S & B ESTATES, RESUBDIVISION OF LOT 1,
RESUBDIVISION OF LOTS A, B, AND C

The purpose of this application is to resubdivide three existing lots into two lots, and to remove a curb-cut limitation from a previous subdivision approval.

APPLICATION NUMBER 12 DATE June 1, 2006

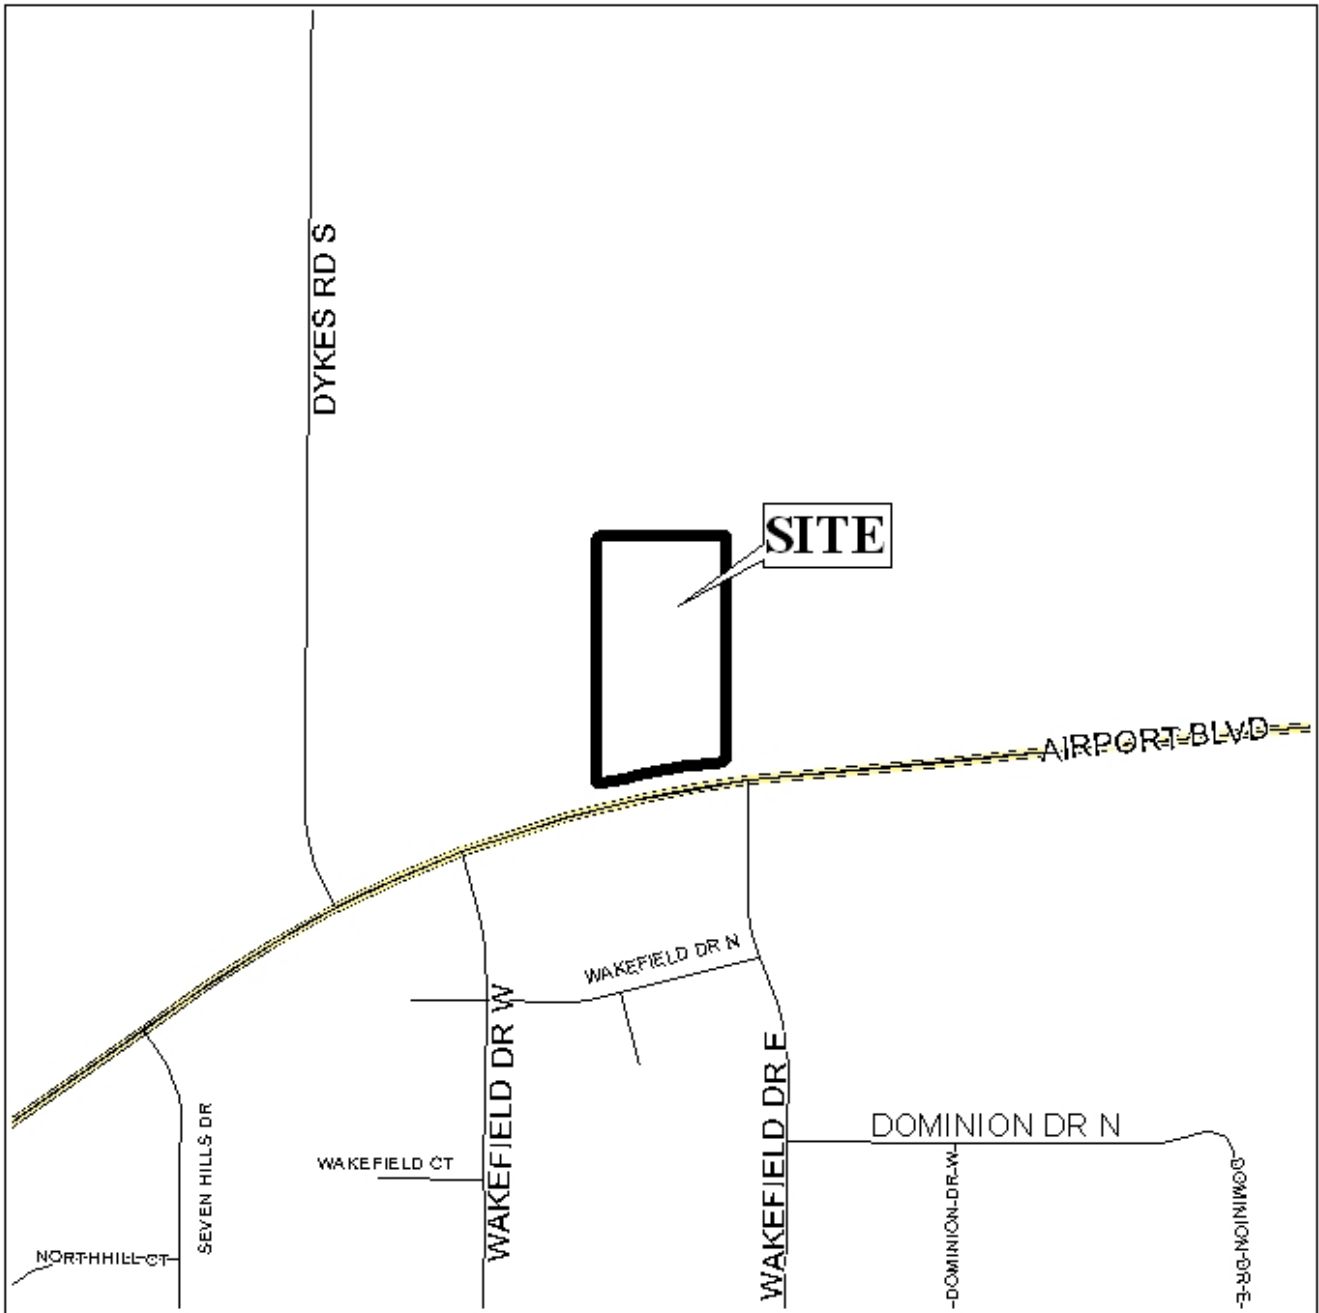
Airport Boulevard is a proposed major street. The preliminary plat indicates that Airport Boulevard's existing right-of-way is 80 feet, however, the Major Street Plan requires that the right-of-way be 100 feet. The previous approved subdivision fulfilled the dedication requirements for the site, which is reflect on the preliminary plat under consideration, therefore no additional right-of-way will be required for this application.

While access management is still a concern for the site, the staff concurs with the applicant's request of one curb-cut for the proposed Lot 1, and one curb-cut for the proposed Lot 2. The size, design and location of all curb-cuts must be approved by the Mobile County Engineering Department.

The proposed Lot 2 exceeds the depth to width ratio of 3.5 recommended by Section V.D.3. of the Subdivision Regulations. As the original lot was previously approved in this configuration, a waiver of Section V.D.3. may be appropriate.

With a waiver of Section V.D.3., the plat is recommended for Tentative Approval, subject to the following conditions: 1) placement of a note on the Final Plat stating that Lots 1 and 2 are limited to one curb-cut each onto Airport Boulevard, with the size, design and location of all

curb-cuts to be approved by the Mobile County Engineering Department; and 2) placement of a note on the Final Plat stating that any lots which are developed commercially and adjoin residentially developed property must provide a buffer, in compliance with Section V.A.7. of the Subdivision Regulations.
